Design and Access Statement

E4905 105 Pound Lane, Sonning, RG4 6GG

March 2026
Rev A

Pre-planning feedback

1 Proposed Mound Section C-C
1:100

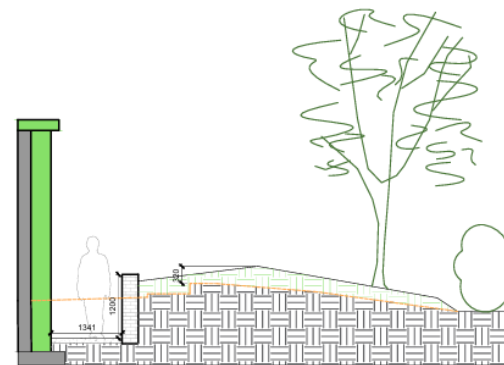
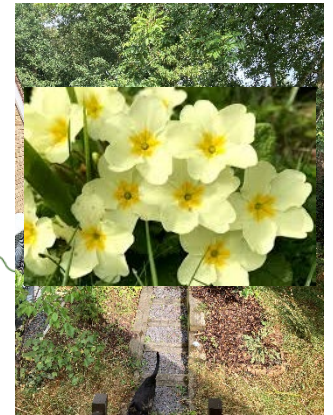
'The Proposed Site Plan indicates removal of some vegetation on the southern boundary adjacent to railway land to facilitate a new retaining wall and associated infill behind the wall. If an application is submitted, we will need details of the extent of vegetation removal, retaining wall and replacement planting along the southern boundary in accordance with Local Plan policy CC03. It would be helpful for several cross-sections to also be included in association with plans.'

Tree survey and landscape plans have been submitted with this application and several cross sections.

Figure 19 Example of EWI system proposed

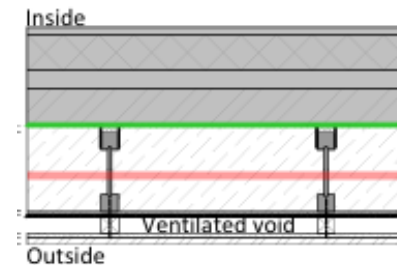
'In this case the maximum eaves height and ridge height of the main dwelling would only be increased by approximately 0.25m and the rhythm of buildings along the street frontages would not be interrupted as a result. The front porch would project approximately 1m forward of the building line and would be single storey. The width and height of the proposed front dormer extension would be in line with existing. Furthermore, the alterations to the garage will not increase the footprint and would be mainly screened from public view by the green vegetation on the front boundary. Specifications of the external appearance of the new insulation/cladding system should be provided for assessment with any subsequent planning application.'

Details of the proposed materials and detail of proposed EWI wall build up can be found on page 15 of this report.
